BID BULLETIN NO. 01

5 October 2020

Name of Project: **Supply, Delivery, and Installation of Modular Partitions and Mobile Pedestal for Fifth and Sixth Floors of the Central Office Administration Building**

TESDA MAIN BUILDING 1
PROPOSED OFFICE PARTITION ISOMETRIC

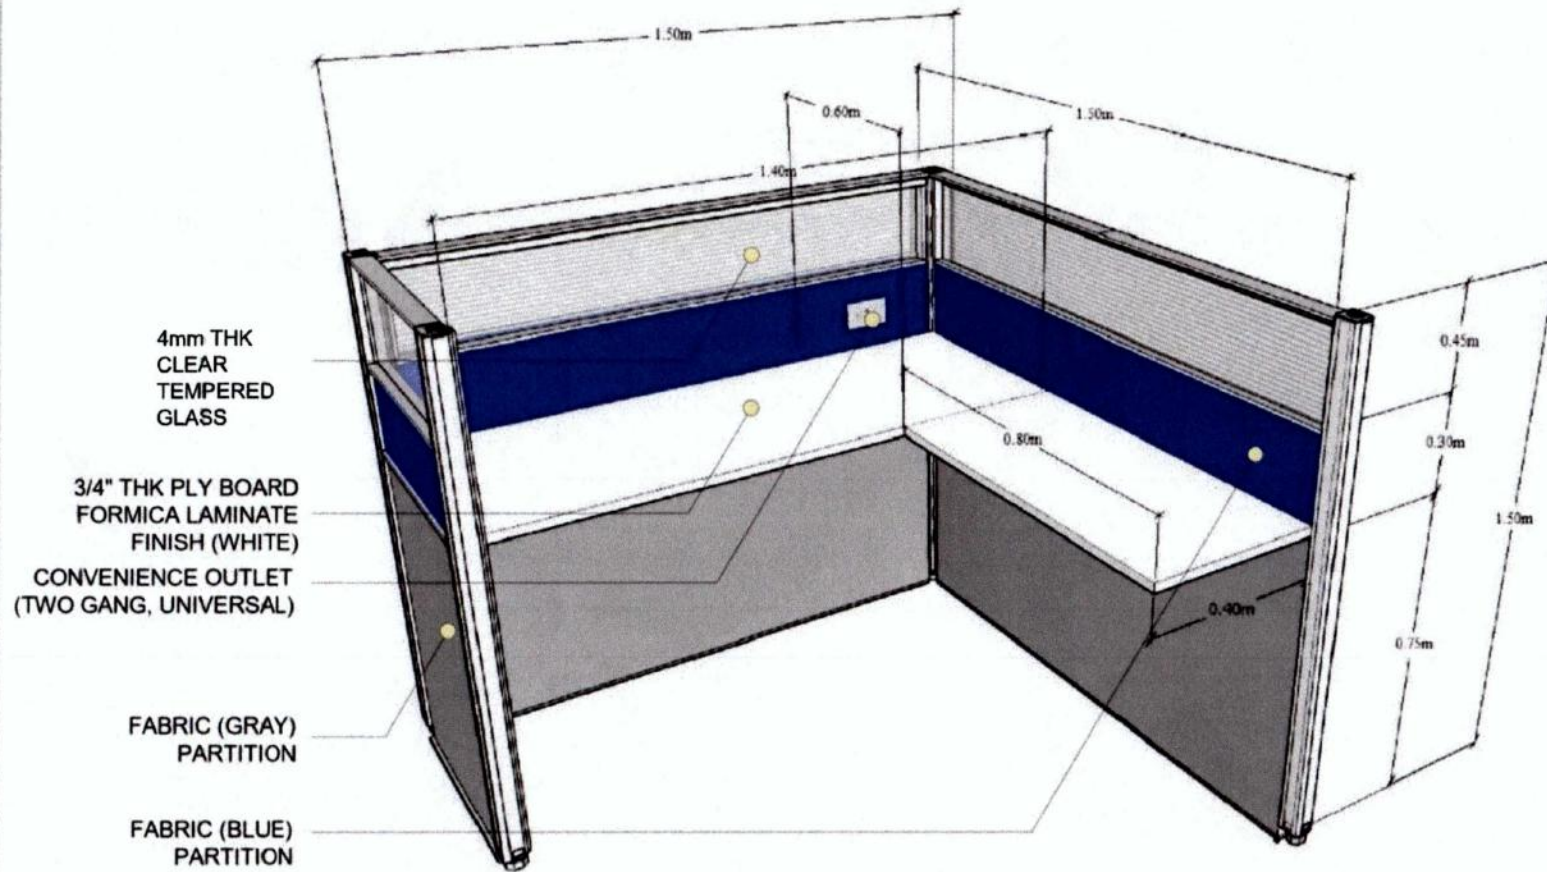
RESPONSE	Yes, the TESDA specifications do not require railways at the bottom of the partition but one of the requirements is to have a convenience outlet at the top of the table.				
QUERY # 2	Which will prevail between the Technical Specs and the Drawing since the color of the Fabric Partition as specified in the Technical specifications is Gray but appeared to be two-tone (Blue and Gray) in the Drawing/image?

ORIGINAL	AMENDED				
<ul style="list-style-type: none"> Fabric Partition; Color (Gray); dimensions is as per inside edge to edge of aluminum frame as per plan. 	<ul style="list-style-type: none"> Fabric Partition; <u>Color (blue) on upper portion of the partition and (gray) at bottom. See Annex "A"</u> 				
QUERY # 3	Clarification on the required Panaflex if fixed as indicated in the Technical Specifications is 4mm thick Panaflex (clear) Partition while in the drawing is Clear Glass Partition.

RESPONSE	<p>After due consideration and in coordination with the End-user and TWG, the BAC decided to amend the requirement under Item No. 1 of Section VII. Technical Specifications of the Bidding Documents into:</p> <table border="1"> <thead> <tr> <th>ORIGINAL</th> <th>AMENDED</th> </tr> </thead> <tbody> <tr> <td> <ul style="list-style-type: none"> Fabric Partition; Color (Gray); dimensions is as per inside edge to edge of aluminum frame as per plan. </td> <td> <ul style="list-style-type: none"> Fabric Partition; <u>Color (blue) on upper portion of the partition and (gray) at bottom. See Annex "A"</u> </td> </tr> </tbody> </table>	ORIGINAL	AMENDED	<ul style="list-style-type: none"> Fabric Partition; Color (Gray); dimensions is as per inside edge to edge of aluminum frame as per plan. 	<ul style="list-style-type: none"> Fabric Partition; <u>Color (blue) on upper portion of the partition and (gray) at bottom. See Annex "A"</u>

RESPONSE	<p>After due consideration and in coordination with the End-user and TWG, the BAC decided to amend the requirement under Item No. 1 of Section VII. Technical Specifications of the Bidding Documents into:</p> <table border="1"> <thead> <tr> <th>ORIGINAL</th> <th>AMENDED</th> </tr> </thead> <tbody> <tr> <td> <ul style="list-style-type: none"> 4 mm THK Panaflex (clear) partition; </td> <td> <ul style="list-style-type: none"> 4 mm THK <u>Clear Tempered Glass</u> partition. See Annex "A" </td> </tr> </tbody> </table>	ORIGINAL	AMENDED	<ul style="list-style-type: none"> 4 mm THK Panaflex (clear) partition; 	<ul style="list-style-type: none"> 4 mm THK <u>Clear Tempered Glass</u> partition. See Annex "A"
ORIGINAL	AMENDED				
<ul style="list-style-type: none"> 4 mm THK Panaflex (clear) partition; 	<ul style="list-style-type: none"> 4 mm THK <u>Clear Tempered Glass</u> partition. See Annex "A"
